# **Logan River Watershed Plan EA**

## **Scoping Report**

Prepared by: J-U-B ENGINEERS, Inc.

October 2021

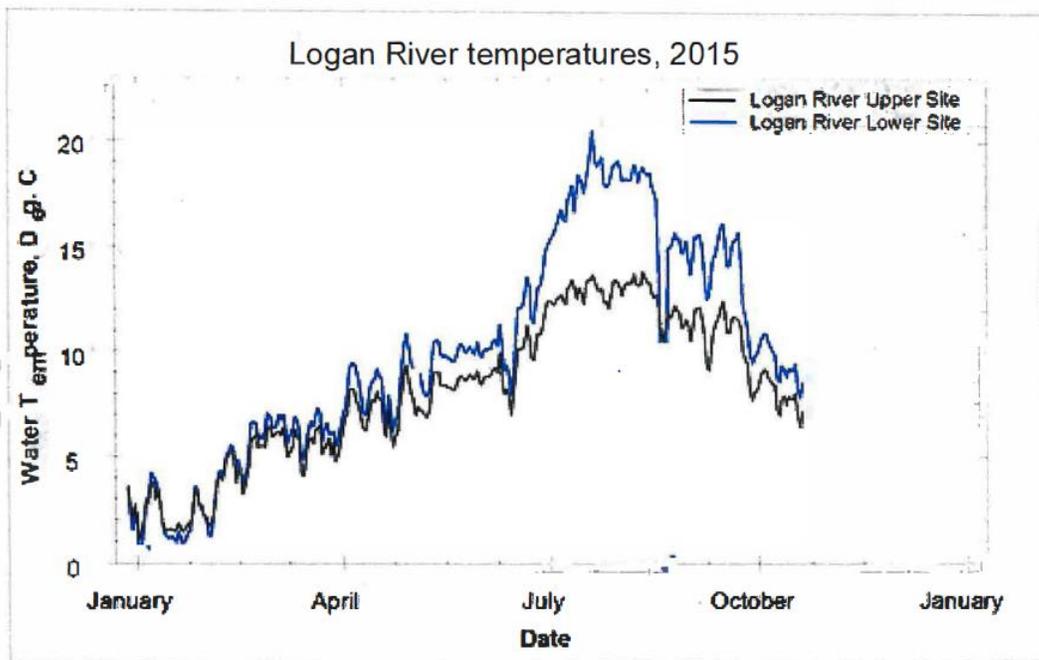
I wish to express my concern about a proposed project on the Logan River which would divert water for pressurized irrigation for residents of Cache Valley. I understand that the project is still in the planning stage and the proposed diversion is just one alternative. That said, I strongly feel that any action that removes a significant amount of the summer flow from the Logan River between First Dam and Cutler Reservoir would put fish populations in the river at risk.

As USU's water quality Extension Specialist, I have compared water temperatures with temperature criteria in rivers across the state. Attached is a graph of water temperatures at two sites on the Logan River-one at the mouth of Logan Canyon and the other near the river crossing at Main Street. These were recorded in 2015 as part of a research project. As you can see, the temperatures diverge significantly in mid-June, at the same time that irrigation water diversions began at the Crockett Diversion. The year before, many of the mature riparian trees that had shaded the river just downstream of this diversion (along Riverside Drive) had been removed in an attempt to reduce debris in the river. The river bottom was also flattened and widened slightly in this reach. The reduced flows and manipulation of the river, combined with a loss of shading, caused the river to rapidly heat up in this reach.

Utah Code R317.2 classifies the Logan River as 3A, which protects its waters as a cold-water fishery (primarily for trout). The water temperature is not to exceed 21 degrees Centigrade. Note that this criterion was exceeded briefly in 2015. Since that time, more shade trees have been removed along several extensive river reaches between S 100 East and Rendezvous Park. Revegetation efforts have begun, but it can be difficult to get trees established and once they are successfully replanted, it will take years before the trees mature sufficiently to produce shade needed to protect the river. I urge the Langdon Group and those promoting this project to take all actions possible to protect cold water temperatures and the cold-water fishes these temperatures sustain along the lower Logan River.
